STAFF REPORT

NEW BEDFORD HISTORICAL COMMISSION MEETING

LOCATION: 72 N Water Street
Map 53 Lot 68

APPLICANT: Mount Vernon Group
Architects, Inc.

B. PAVERS

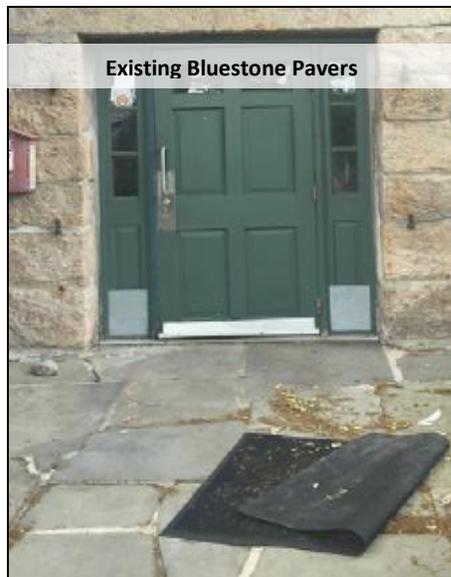
Universal access to the building is through the lower level courtyard entrance, which is below the grade of N Water Street. The walkway from the parking area to the lower level entrance currently consists of broken and uneven bluestone set in failing concrete. The applicant is proposing to replace the bluestone with a dark grey architectural slab concrete paver in various sizes to emulate the color and design of the bluestone but with a material change that will hold up better than the bluestone over the long term.

Because bluestone, due to its condition and its installation in concrete, makes it unsuitable for replacement in-kind, staff recommends the approval of the proposed paver. The location of the pavers is below sidewalk grade and the color and material design is appropriate for the landscape setting and preferable for a universal access location.

C. FENCE

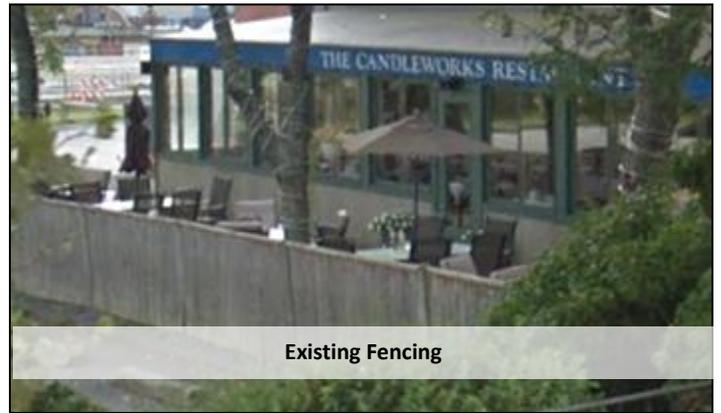
The applicant proposes to replace an existing unpainted wood fence which separates the courtyard outdoor dining patio from the parking area with a 54" high painted wood fence based on the design of the "typical" fence used throughout the District. This same type of fence is also proposed to act as screening for the HVAC condensor unit adjacent to the lower level entry, as well as for the dumpster pad located at the southeast corner of the building. (See attached site plan for locations.)

Staff recommends approval of the fence at the proposed locations and dimensions with the condition that the fence be painted in the color green to match the existing building trim.

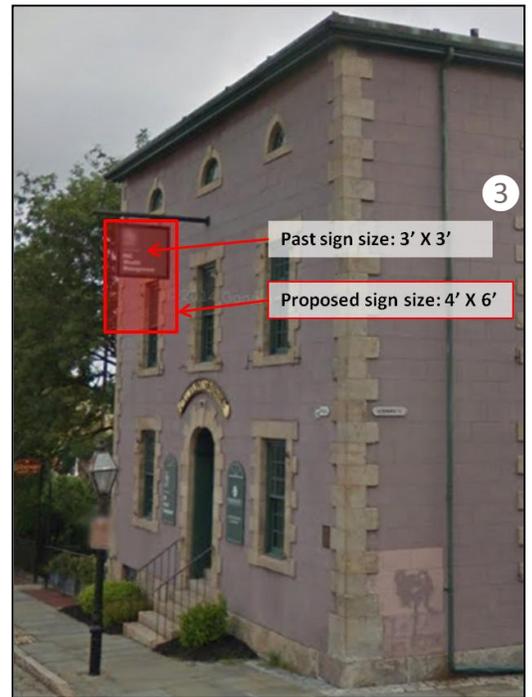
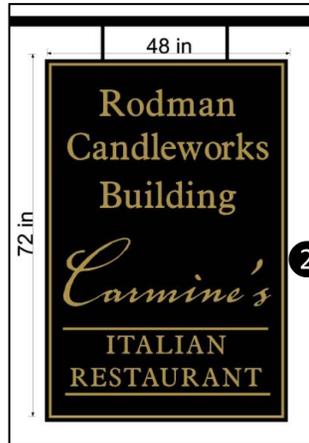
The proposed blade (projecting) sign (2) to be located above the N Water Street entry is an unlit double sided, 48" wide by 72" long sign that will be installed on an existing bracket (3).

A second existing bracket (4) is also located at the N Water Street entry to the Courtyard, which serves as the main entry to the restaurant located in the lower level of the building. The proposed blade sign (5) is double sided, 20" wide by 22" long and will be installed on the existing bracket. The sign would be unlit.

- All of the proposed building signs' material and design compliments the architecture of this significant resource and great care should be taken with their installation. However the scale of the N Water Street bracket sign (24 sq. ft.) distracts from the building's main façade. Staff recommends the Commission give consideration to a sign of lesser scale than which is being proposed.
- The proposed aluminum parking lot sign did not specify location(s). Staff recommends their approval with the condition that their locations at each parking lot entry be determined by the Commission or be delegated to planning staff.
- The canopy signage is similar to what has been allowed in the past and staff recommends its approval as presented.

Existing Signage

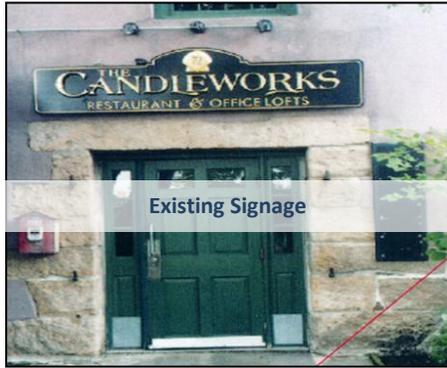
The applicant also proposes to replace two existing building signs currently located on the north façade of the building at the courtyard level: a wall sign, 26" X 96" above the lower level entrance, and a directory sign, 15" X 46" adjacent to the entry.

Lighting for the wall sign previously exists. Both are being replaced with signs of the same design and dimensions.

Proposed Parking Lot Sign

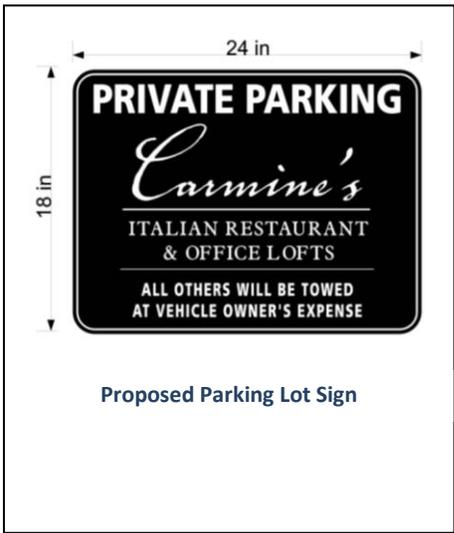
An unlit ground sign exists at the corner of Elm Street and the JFK Boulevard. It currently has white painted posts which are 12' in height. The applicant is proposing to replace the current panels with new panels of the same size to reflect the building's new occupants and uses.

The panels will be constructed of medium density overlay (MDO) plywood, painted white with black lettering.

The ground sign as presented will require a variance because of the proposed size of the top portion (30 SF) exceeds that which is allowed under zoning (25 SF). If the applicant reduces that section accordingly, it would not require the variance.

The current ground sign at Elm Street and JFK Boulevard was modified and its height increased from 8' to 12' in 2010 and is larger in scale than what is normally approved within the District. The proposed top sign component has an area of 30 square feet. Municipal Code of Ordinances stipulates that ground signs within the Mixed-Use Business Districts not to exceed 25 square feet in area. As such, the proposed sign should be reduced to 25 square feet, which will provide better compatibility to the site.

The applicant has proposed signage components with a white painted background with black lettering. The light color of the signage will act to exaggerate the size of the ground sign, and staff recommends that the sign posts and sign components be painted either black or dark green with white lettering in an effort to reduce the scale of the ground sign.

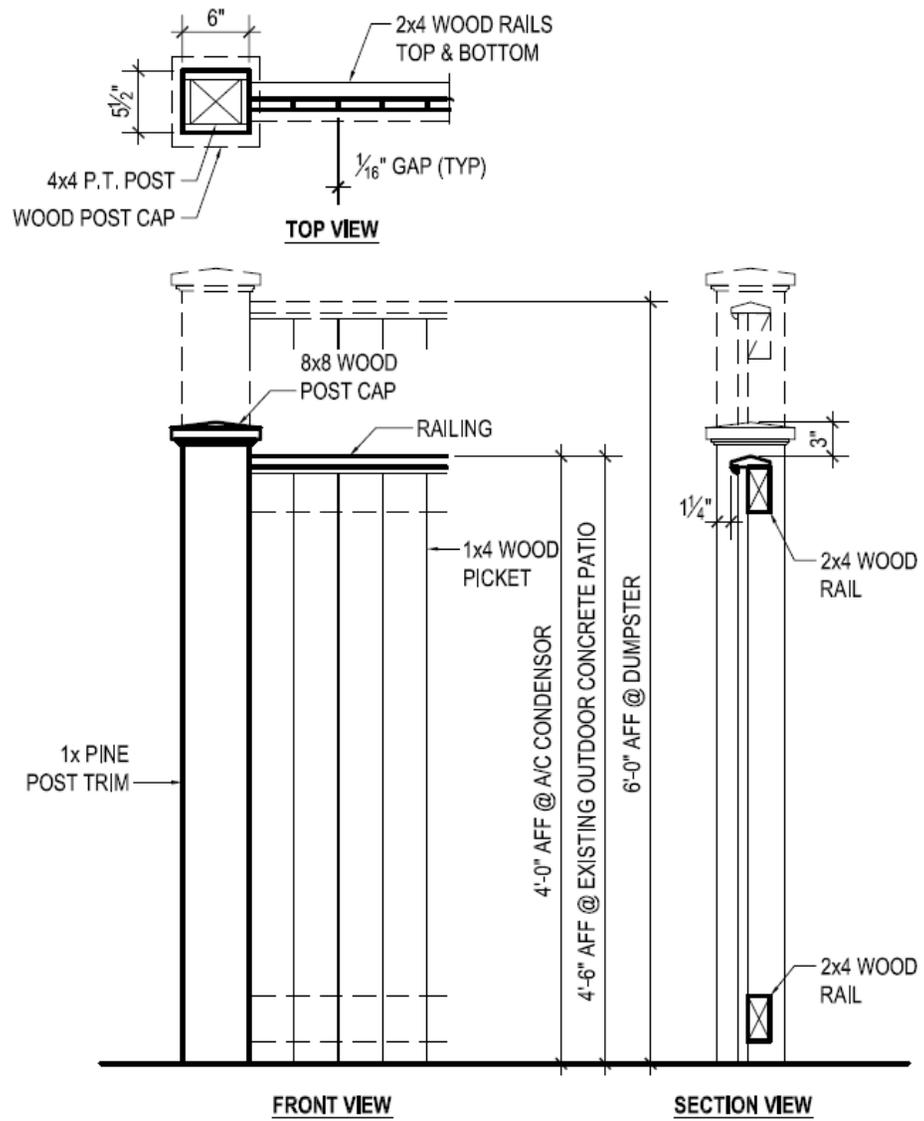
NOTE:
WOOD FENCING SHALL BE PAINTED GREEN TO MATCH EXISTING.

PROPOSED WOOD FENCE (NOTE NO SPACING BETWEEN PICKETS)
